# H.E.S. No. 3 EXCHANGE PROHIBITION

Q407  
ISSUE C

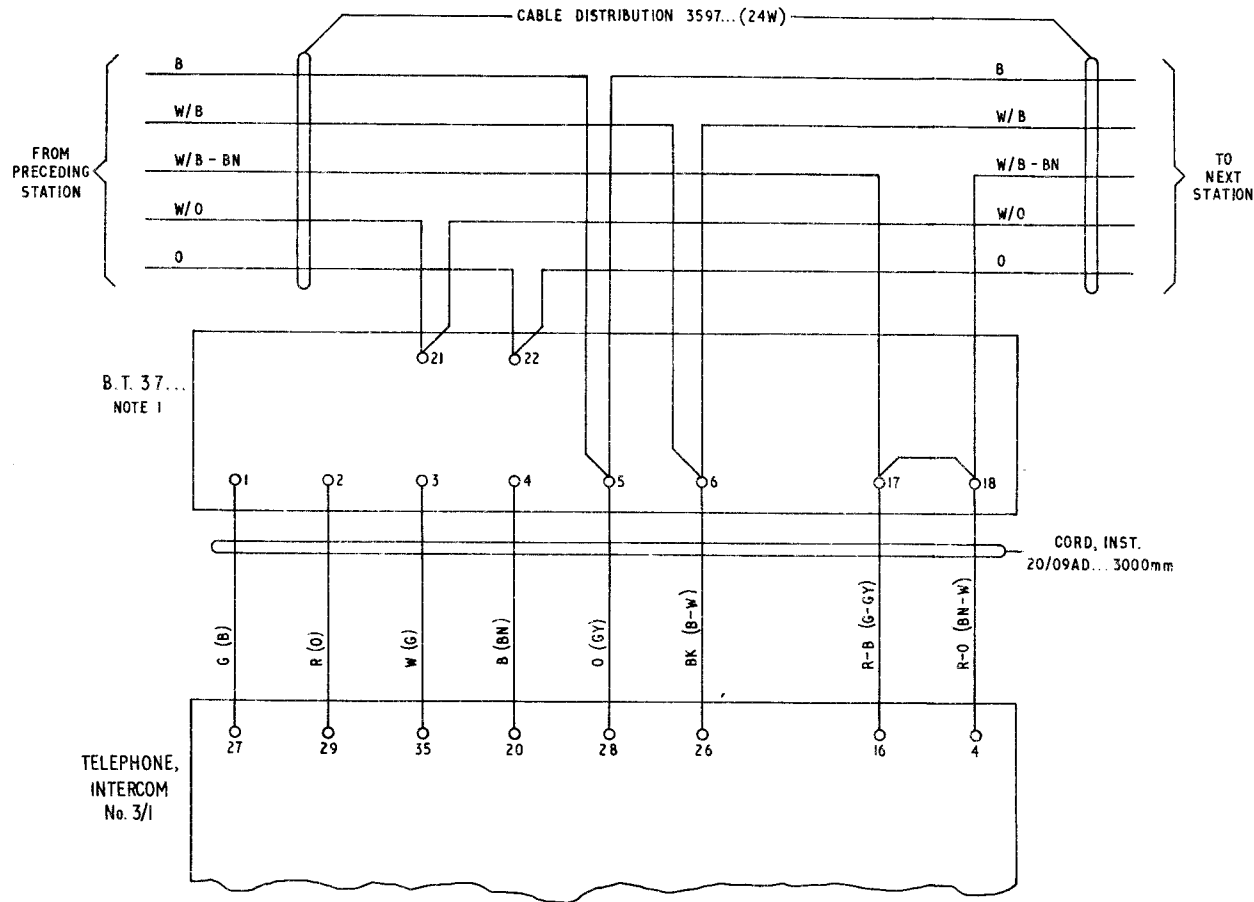
1. The following wiring changes should be made in the B.T. No. 37 at the stations which are not permitted to make or receive exchange calls.  
 Transfer 'B' wire from Terminal 2 to 5.  
 Transfer 'W/B' wire from Terminal 1 to 6.  
 Transfer 'O' wires from Terminal 4 to 22.  
 Transfer 'W/O' wires from Terminal 3 to 21.  
 Strap Terminals 17 and 18.
2. Cord conductor colours shown in brackets refer to Cord Inst. No. 20/03AJ...
